05.1-27

TECHNICAL BULLETIN

Insufficient AIR Flow – AIR Pump (AIRP) – Diagnosis

MODEL 1995-97 MY
Sedan (4.0L) Range
VIN
720001-779500

ILLUSTRATION 1

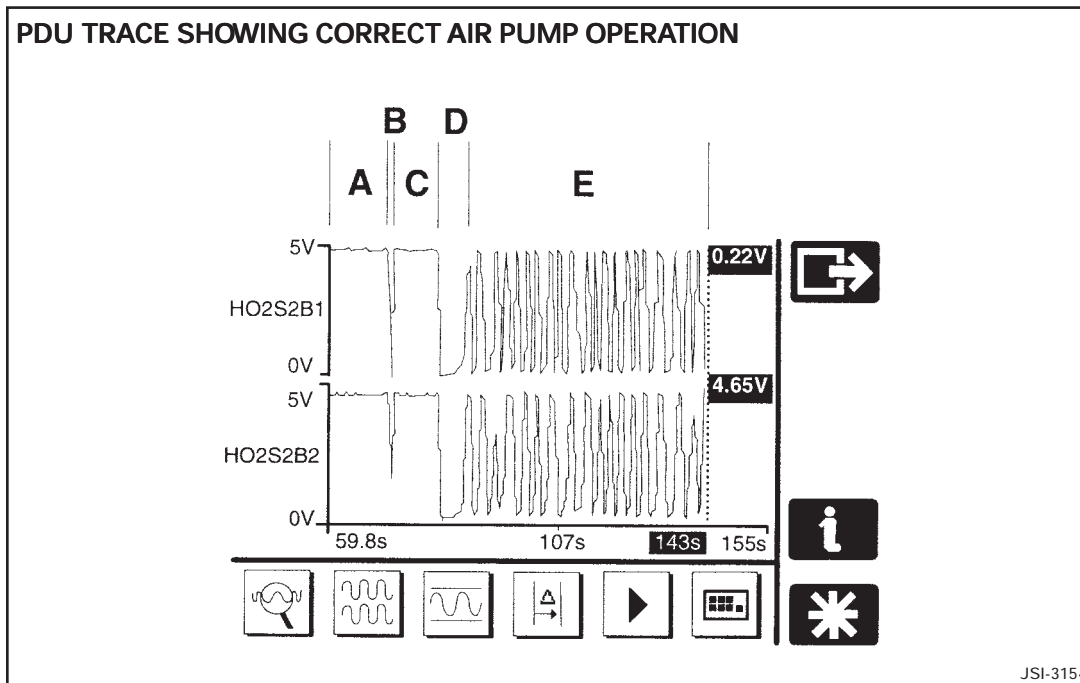
The AIR pump operates for a short period of time following every engine start. It typically operates for approximately 10-20 seconds at normal operating temperatures, then switches off for approximately 5-10 seconds, and then restarts to allow the system diagnostic check to occur. This check also takes approximately 5-10 seconds. See Illustration 1, sample of PDU trace. This complete cycle takes place each time the engine is started. **This is the re-test referred to in the flow chart.**

- Zone 'A' shows the initial operation of the air pump (air flow causes lean reading).
- Zone 'B' shows the pump switched off, prior to the diagnostic test (stopping air flow causes rich reading).
- Zone 'C' shows the pump operating during the diagnostic test cycle.
- Zone 'D' shows the pump switched off when the test is complete.
- Zone 'E' shows the lambda voltage switching under normal lambda operation.

ILLUSTRATION 2

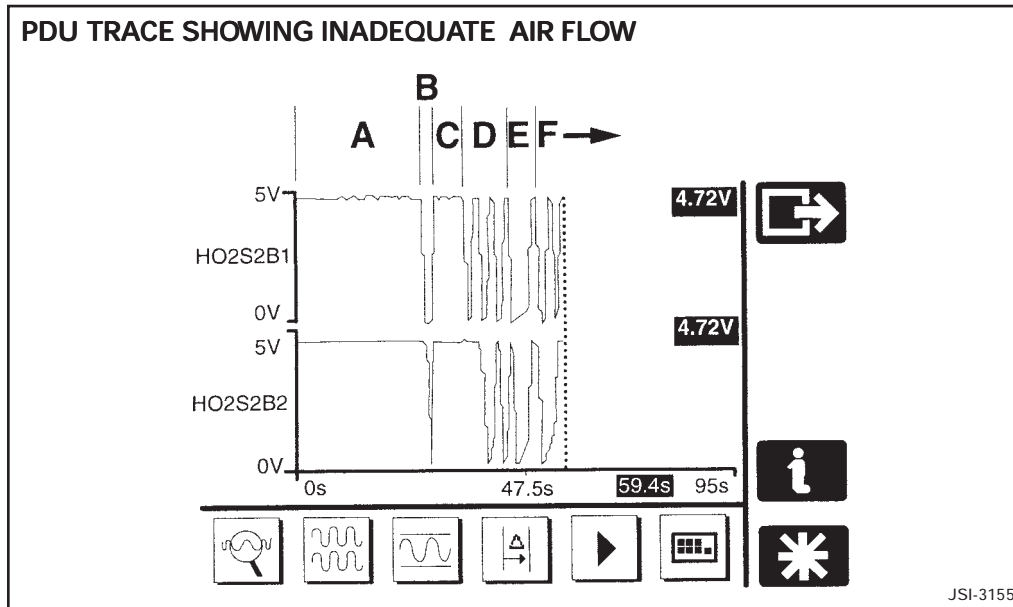
Illustration 2 shows a PDU trace where there is inadequate air flow from the air pump.

Zone 'A' shows the initial operation of the air pump (air flow causes lean reading).

Zone 'B' shows the pump switched off, prior to the diagnostic test (stopping air flow causes rich reading).

Zone 'C' shows the pump operating during the diagnostic test cycle.

Zone 'D' shows the lambda voltage switching to normal feedback, as there is insufficient air flow to sustain the voltage at 5v.

Zone 'E' shows the air pump switched off at the end of the diagnostic cycle.

Zone 'F' shows the lambda voltage switching under normal lambda operation.

DIAGNOSTIC FLOWCHART

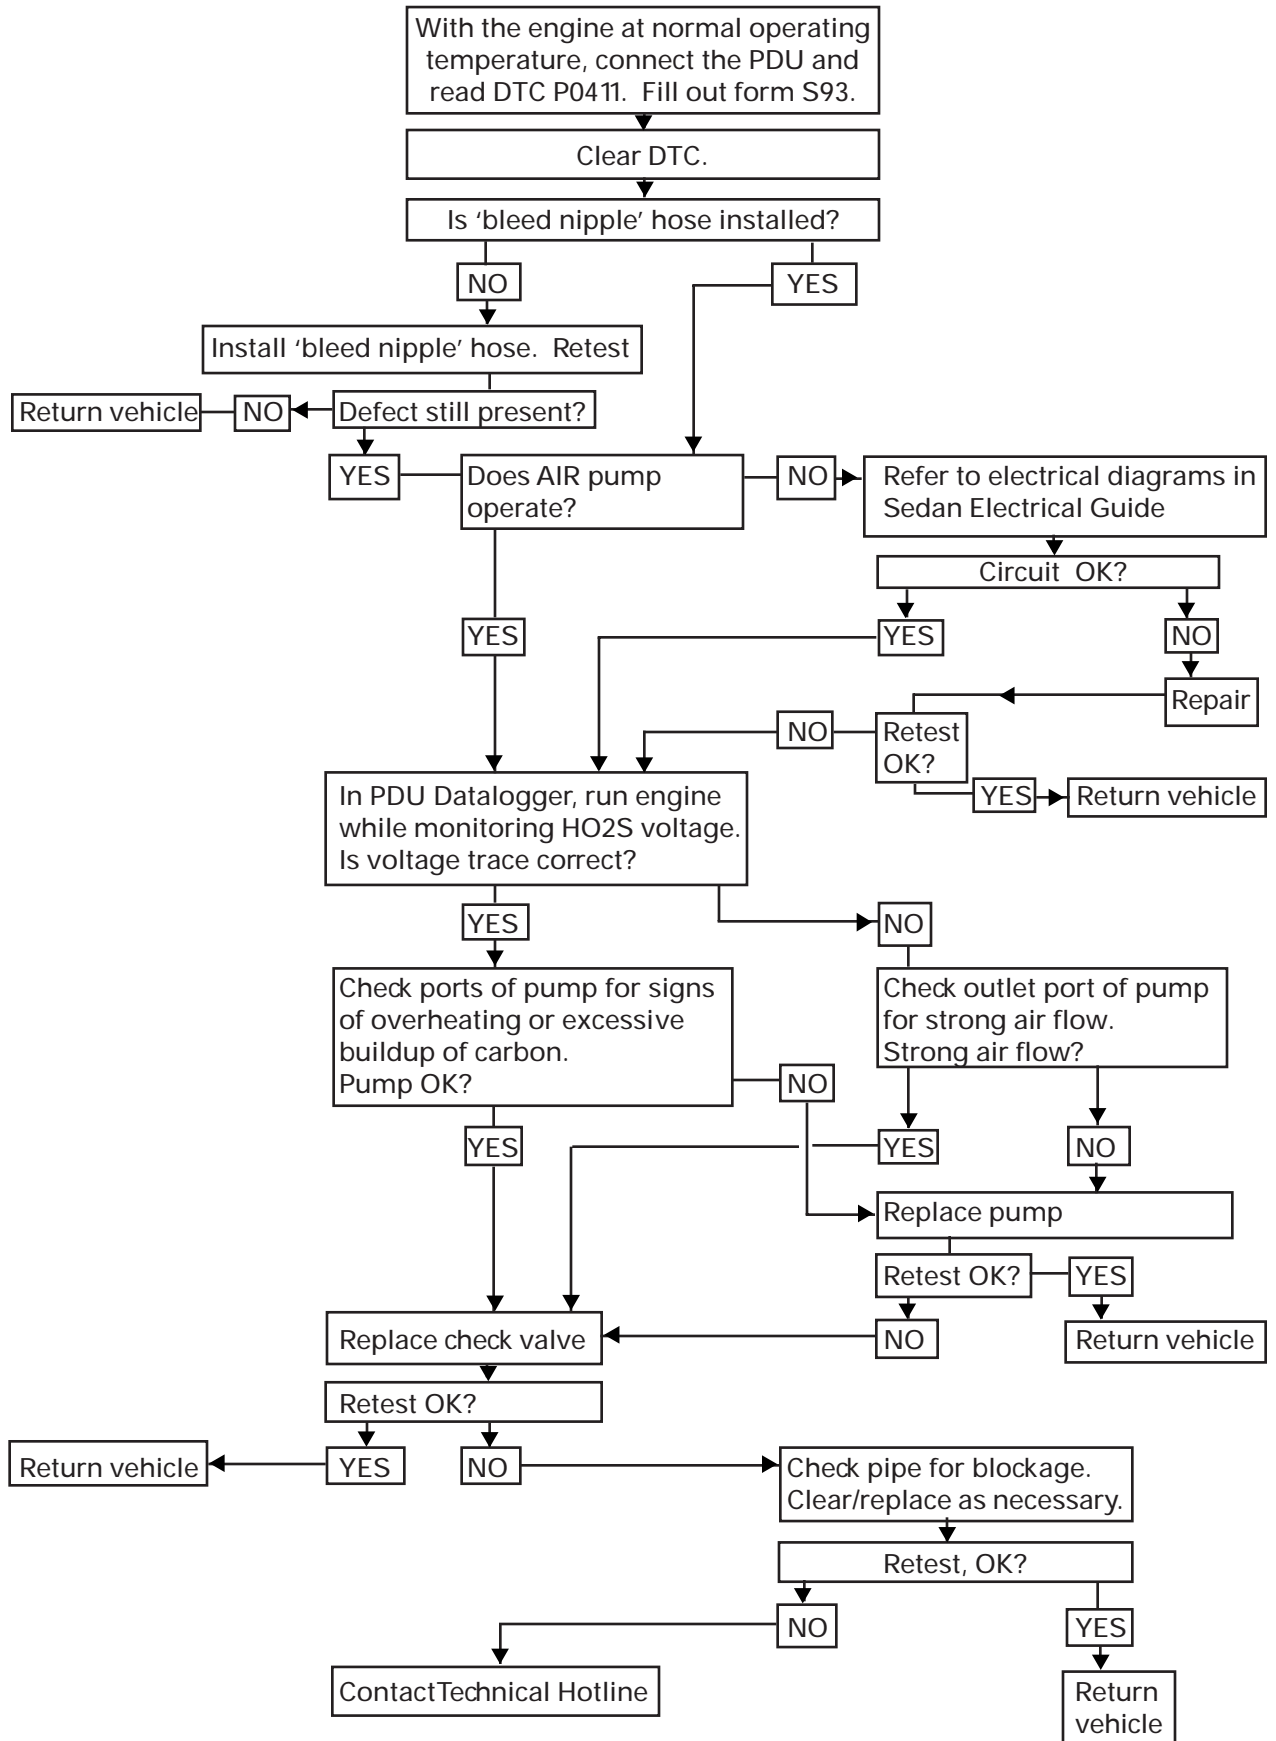
In case of a customer complaint on a Sedan Range vehicle within the above VIN range of MIL illumination, with DTC P0411 flagged, follow the diagnostic flowchart located on the last page of this bulletin. The following text provides additional information.

The statements in boxes correspond to boxes in the flow chart.
